SI M13 01 13
Fuel Systems

August 2013
Technical Service

N14 and N18 Engine: High-pressure Pump Repair Instruction

Continental High-pressure Pump (1):

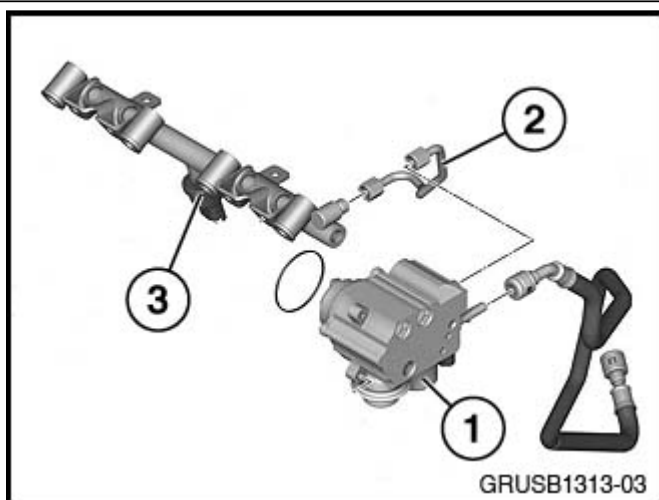
The current version of ISTA/D Repair Instruction 13 51 017, “Removing and installing or replacing high-pressure pump (N14, N18)” has a procedure error. The current version of the Repair Instruction states to replace the high-pressure supply hose on the N14 engine. The Repair Instruction also states not to replace the high-pressure supply hose on the N18 engine. The N18 portion of the Repair Instruction is incorrect. As an interim solution, follow the procedure outlined below until this portion of the Repair Instruction is corrected.

All vehicles equipped with the N14 engine (all production)
All N18 vehicles produced up to 3/2012 are equipped with a Continental High-pressure Pump.

When the N18 engine is fitted with a Continental High-pressure Pump (1), the high-pressure supply hose (2) **MUST** be replaced when making repairs.

Bosch High-pressure Pump (1):

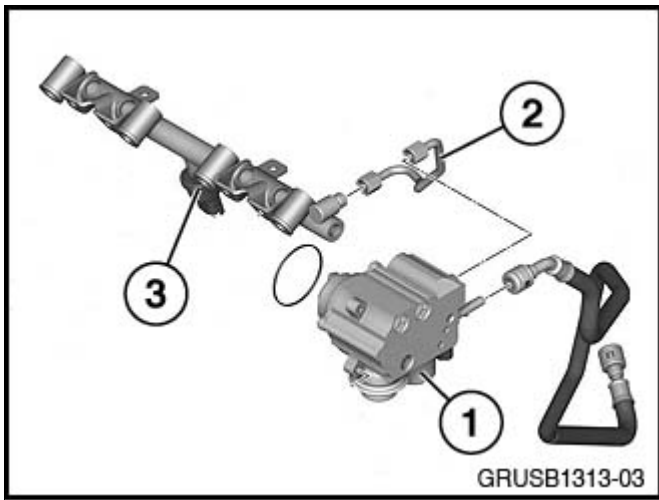
All vehicles equipped with the N18 engine and produced from 3/2012 and later.

When the engine is fitted with a Bosch High-pressure Pump (1) the high-pressure supply hose (2) **MUST NOT** be replaced when making repairs.
